# Code Review

## 2018 Changes to International Codes

### IECC - COMMERCIAL - ENERGY TAC

# Energy Conservation Code (IECC) – Commercial

## Code Change No: **CE97-16**

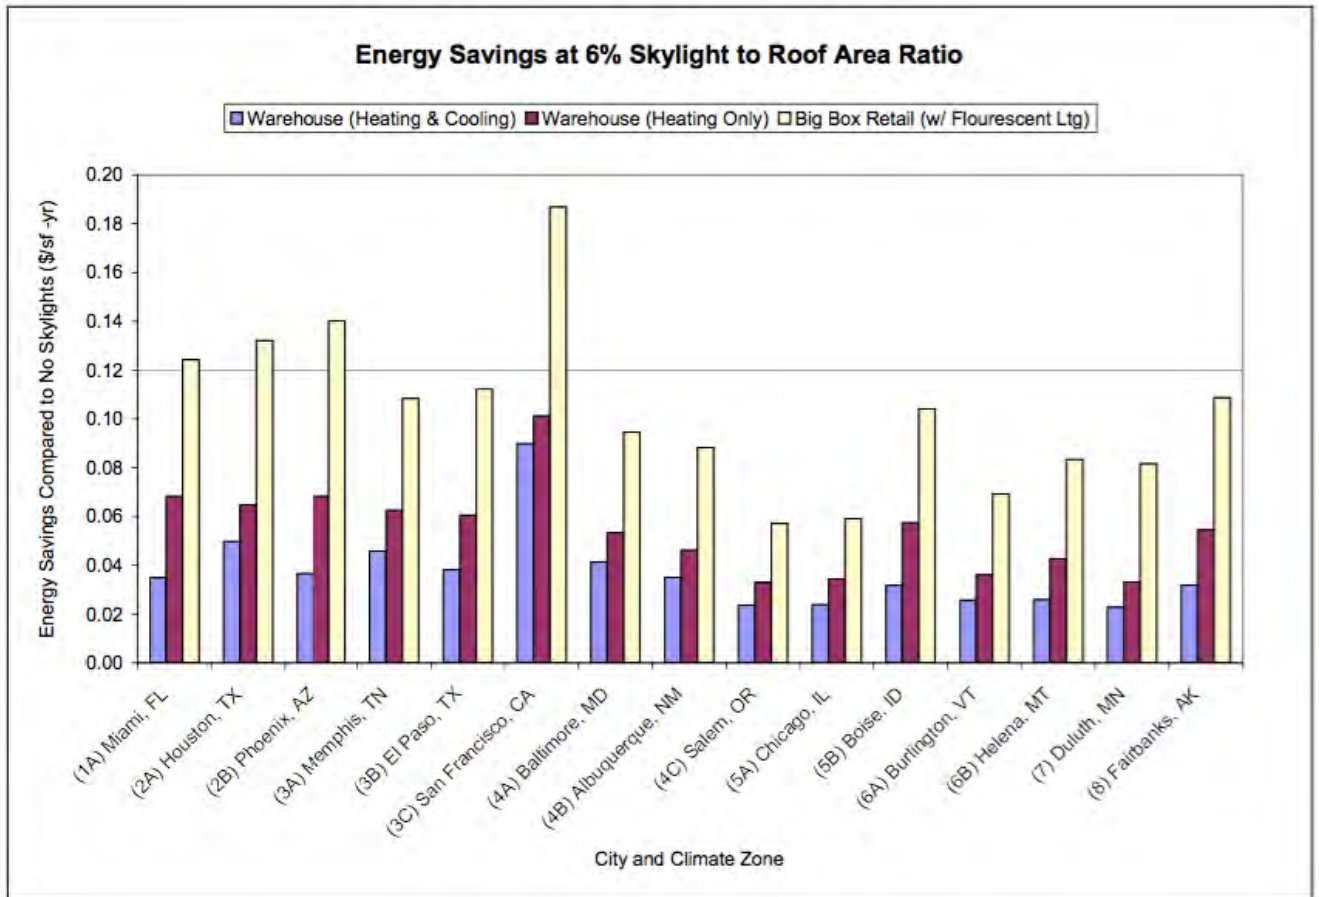
**Section: C402.4.1.2**

**Reason:** When going through the code to do plan review and we get to Section C402.4.1.1 because they are trying to increase the allowed glazing area, we see this requirement for 50% of the net floor area to be within a *daylight zone*.

Figure C405.2.3.2 (1) is now Figure C402.4.4.1(1)

Figure C405.2.3.2 (2) is now Figure C402.4.4.1(2)

Figure C405.2.3.2 (3) is now Figure C402.4.4.1(3)

Figure C405.2.3.3 is now Figure C402.4.4.2
